APPLICATION 25040461

**PROPOSED APARTMENT BUILDING
3 PATAWALONGA FRONTAGE, GLENELG NORTH (APP ID: 25040461)**

Figure 1 - Pedestrian sight line provisions at the access point

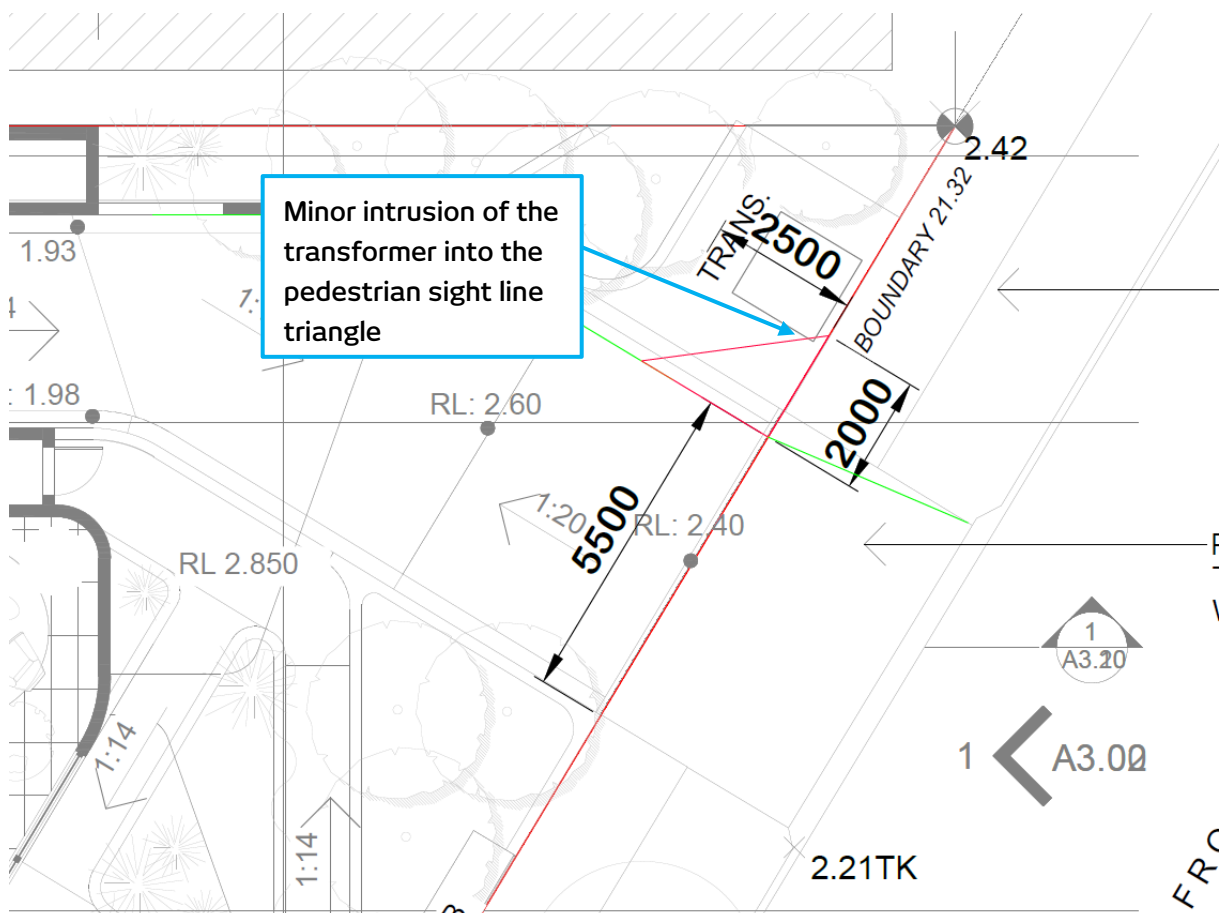
"The transformer located in the north-eastern corner may impede visibility for drivers exiting the basement ramp. If the structure compromises required sightline offsets to pedestrians approaching along the western footpath, this creates a high-risk conflict point. A formal sightline assessment must be provided to verify compliance with relevant safety standards."

The proposed driveway will be categorised as a "low volume (Category 1) access driveway" and therefore has a minimum width requirement of 3.0 m. If this width was adopted, the pedestrian sight line requirement is easily met. Nevertheless, allowing for the two-way entry width of 5.5 m identified by the "Australian/New Zealand Standard for Parking Facilities – Part One: Off-Street Car Parking" (AS/NZ 2890.1), the transformer only has a minor intrusion into the pedestrian sight line triangle (by approximately 80 mm) as illustrated in Figure 1 below. This would have no material impact on safety at the access point (and noting that many other driveways within the surrounding area have greater restriction on the pedestrian sight line provisions with no notable crash history). Nevertheless, if desired, conformance with the Standard could be conditioned and this minor deficiency addressed easily in detailed design.

Figure 2 - Ramp cross section

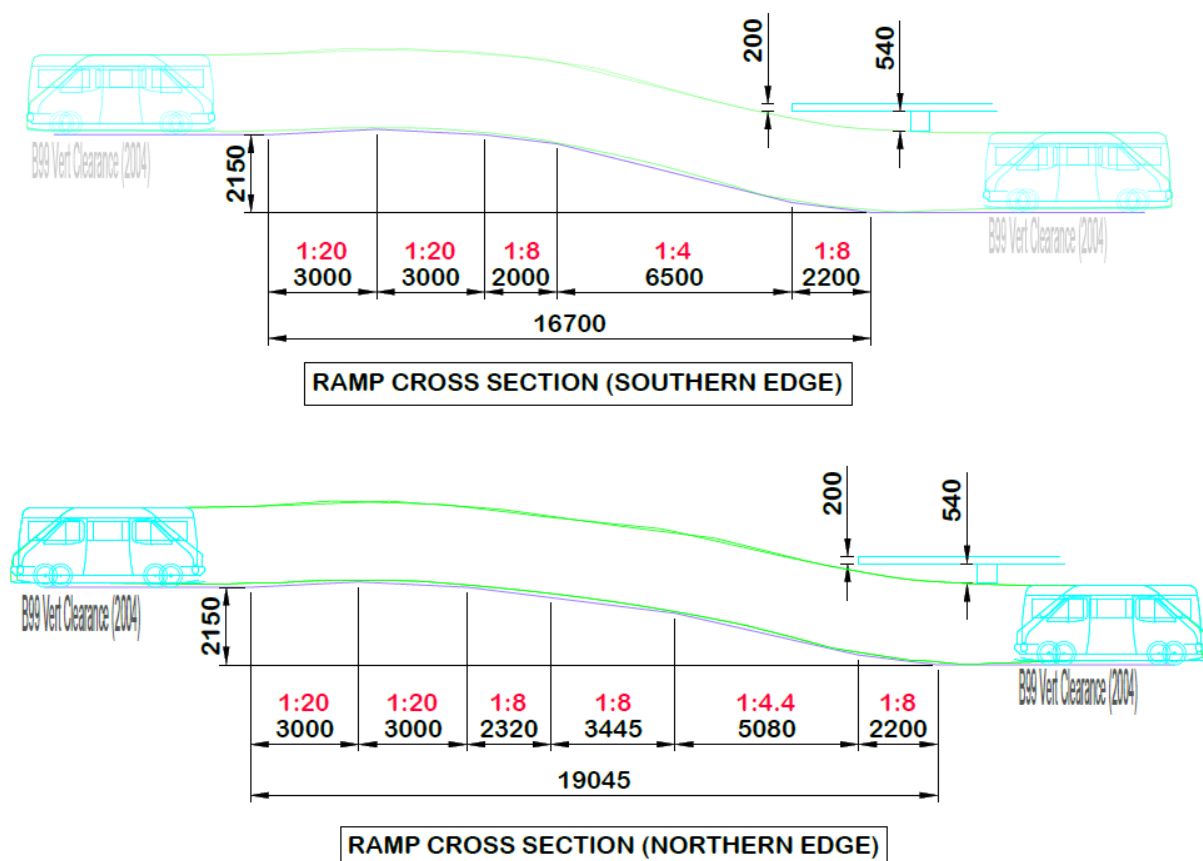
"The vertical clearance on the ramp does not meet the minimum standards of 2.2 m for standard vehicles and 2.3 m for DDA-compliant (disability-accessible) vehicles. Updated ramp designs or compliance justification is required."

There is no requirement for DDA access within the residential building nor any disability parking provision within the site. Therefore, the vertical clearance requirement is a minimum of 2.2 m for standard vehicles. Figure 1 illustrates a cross section of the access ramp with a B99 large design vehicle template (based on 2.2 m vertical clearance).

As illustrated in Figure 1, the minimum vertical clearance of 2.2 m is provided for the access ramp and throughout the site (in fact, 2.4 m clearance is available from base of vehicle to the structure in excess of the requirement suggested by Council).

Figure 4 - On-street bin presentation for nearby medium density developments

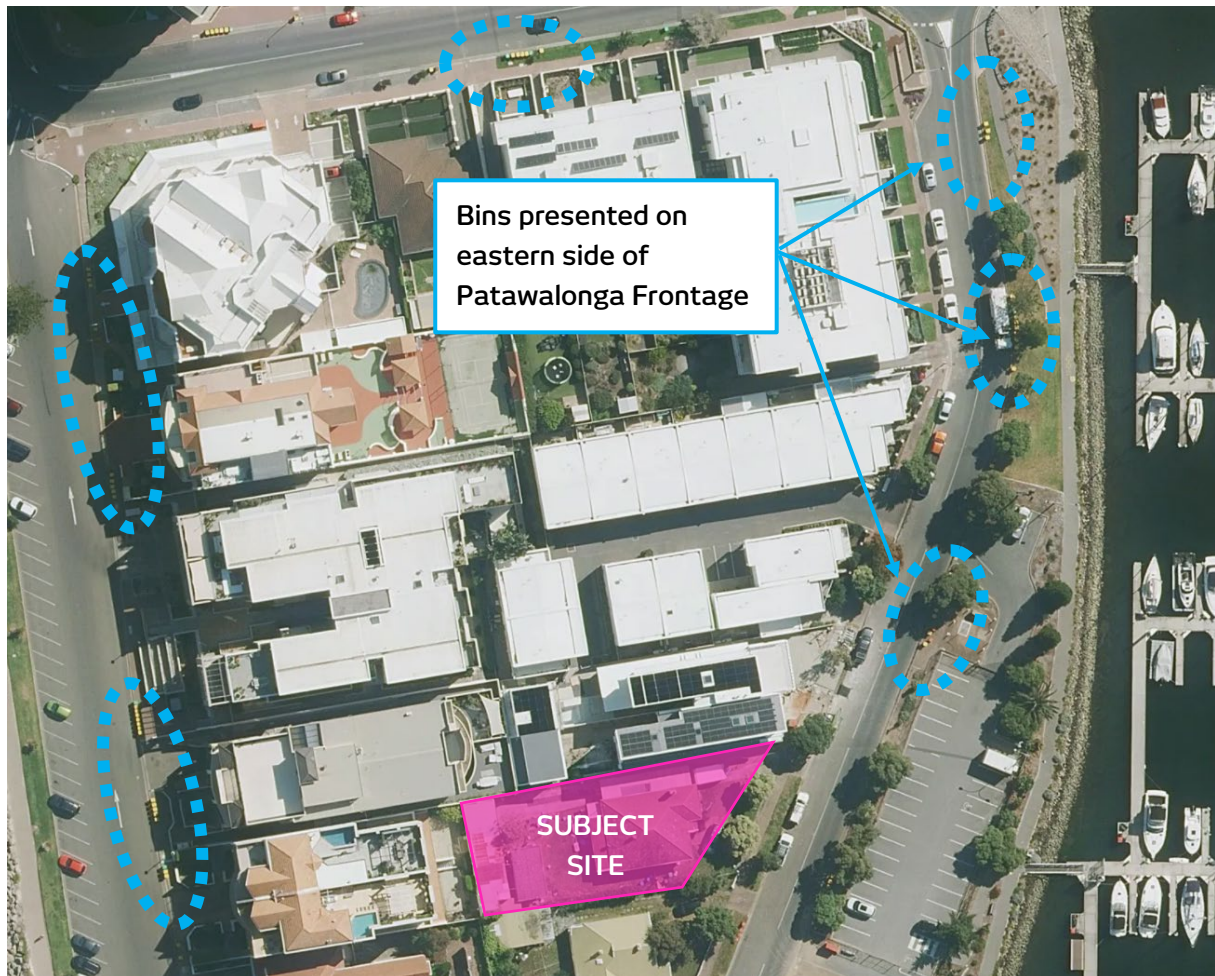
"The current waste strategy requires Council contractors to wheel 660 L bulk bins from the bin room to the kerb via the southern pathway, which ranges from 1.19 m to 2.89 m in width. This presents several concerns:

Navigating multiple bulk bins through a narrow corridor—particularly one that passes adjacent residential interfaces is operationally difficult. This may also create noise and disturbance for the neighbouring property at 2 Patawalonga Frontage. The kerb area appears insufficient to safely and legally accommodate bulk-bin collection. Please clarify:

- Whether parking controls (e.g., "No Stopping" zones during collection) are required,*
- How bin placement will avoid obstructing vehicles, cyclists, and pedestrians, and*
- Whether the kerb structure is designed to withstand repeated bin loading."*

Nevertheless, noting Council's comments, an alternative waste management approach has been recommended based on Council collection and adoption of 240 L bins. This would result in a requirement four (4) general waste bins and six (6) recycling bins (and the original three (3) organic bins proposed). There would be adequate area within the bin
